DEVELOPMENT APPLICATION ASSESSMENT REPORT

Application Number:	DA2025/0324
----------------------------	-------------

Responsible Officer:	Olivia Ramage
Land to be developed (Address):	Lot 23 DP 242281, 38 Parkland Road MONA VALE NSW 2103
Proposed Development:	Alterations and additions to a dwelling house including a deck
Zoning:	R2 Low Density Residential
Development Permissible:	Yes
Existing Use Rights:	No
Consent Authority:	Northern Beaches Council
Land and Environment Court Action:	No
Applicant:	Will Townsend

Figure 1 - East elevation showing envelope breach in red

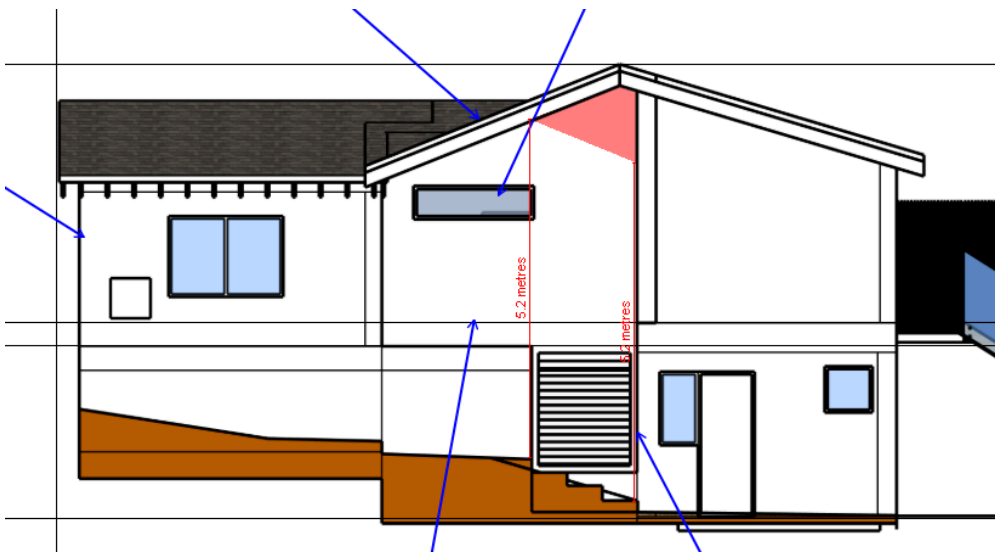
This control requires development to be sited within a building envelope determined by projecting planes at 45 degrees from a height of 3.5m above ground level at the side boundaries. The proposed development encroaches the eastern side building envelope as shown below.

The portion of the building encroaching the envelope is where an existing void is being filled in to provide an ensuite and kitchen storage area. The breach is minor in nature and is primarily due to the slope of the site. The height of the existing dwelling is unaltered and remains below the height of the trees of the natural environment.

As above, the breach occurs due to the infilling of an existing void. This addition retains the existing side setbacks and roof form to ensure consistency with the existing dwelling. As such, the proposed development responds well to the spatial characteristics of the existing natural environment.

Having regard to the above assessment, it is concluded that the proposed development is consistent with the relevant objectives of PLEP 2014 / P21DCP and the objectives specified in s1.3 of the Environmental Planning and Assessment Act, 1979. Accordingly, this assessment finds that the proposal is supported, in this particular circumstance.
